A40 Llanddewi Velfrey - Suggested Alternatives

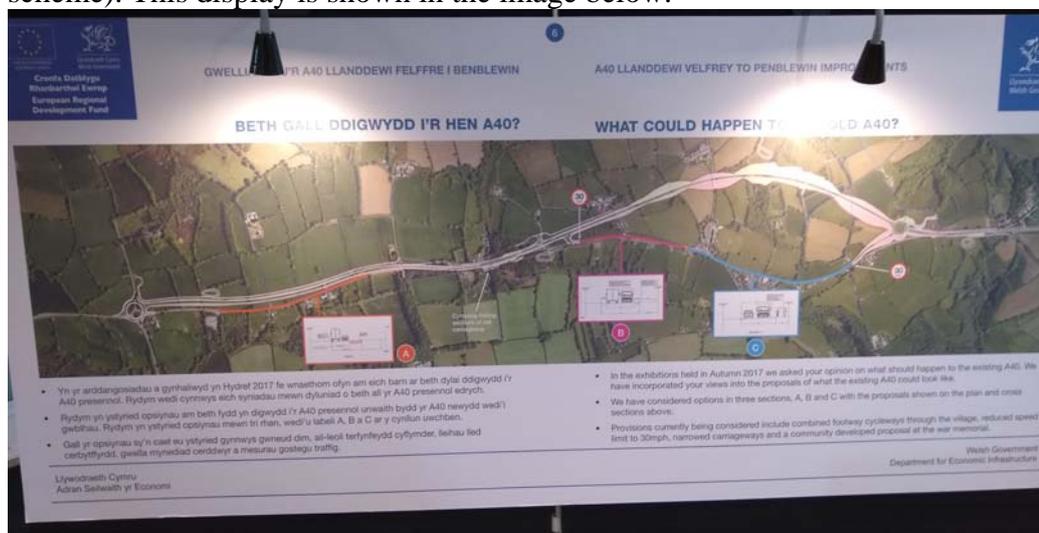
3.5.1. The draft orders exhibition held for this scheme in Llanddewi Velfrey village hall displayed proposals for pavement improvements along the current A40 (which would be de-trunked under the Welsh Government's preferred scheme). This display is shown in the image below.

3.5.2. For the avoidance of doubt, my proposal relates to widening of the current narrow pavement between the junction with Llandaff Row and the east end of the village. This falls entirely within the section marked C (in blue) on the above image.

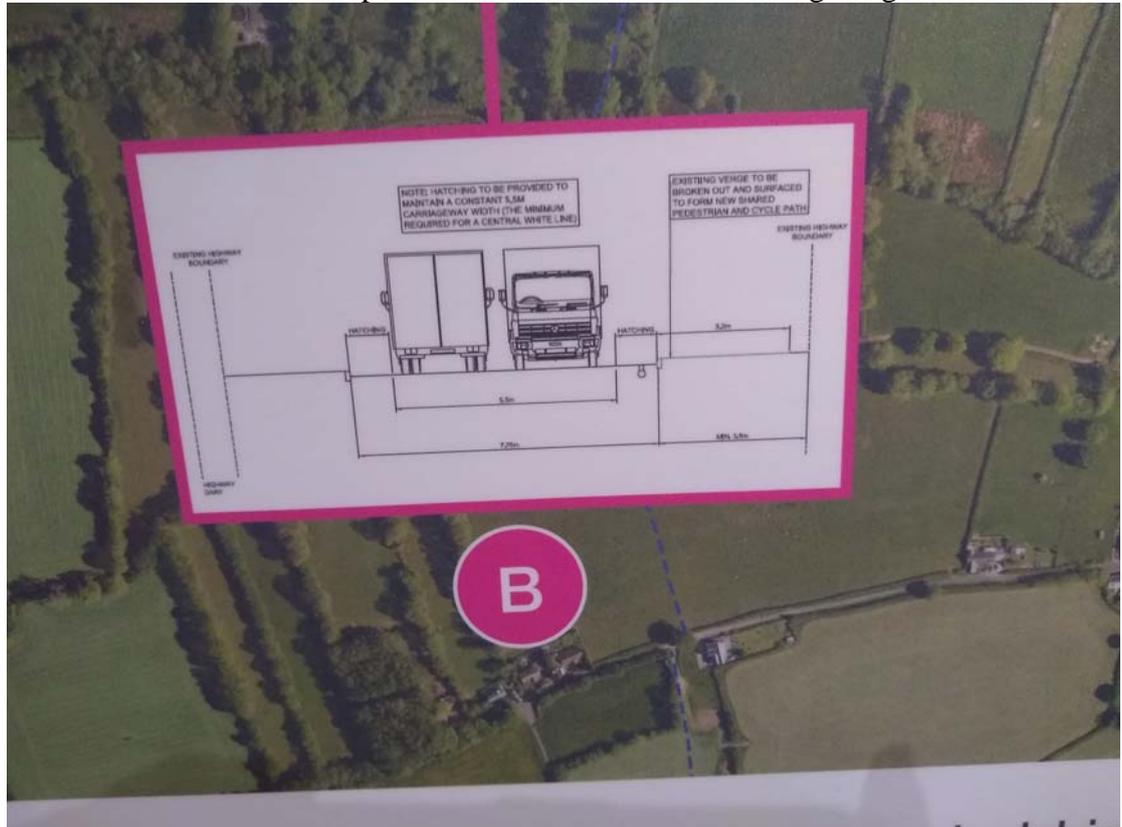
3.5.3. The display at the public exhibition indicated that a carriageway width of 5.5m is the minimum requirement for a central white line and would be sufficient for two lorries to pass. This is shown in the following image.

3.5.4. The Welsh Government's response letter indicates that the current carriageway width is 6.5 metres in places. There is therefore scope to reduce the carriageway width by 0.5m and increase the pavement width by the same amount. The resulting minimum carriageway width of 6m would still be 0.5m greater than the 5.5m minimum identified in paragraph 3.5.3 above.
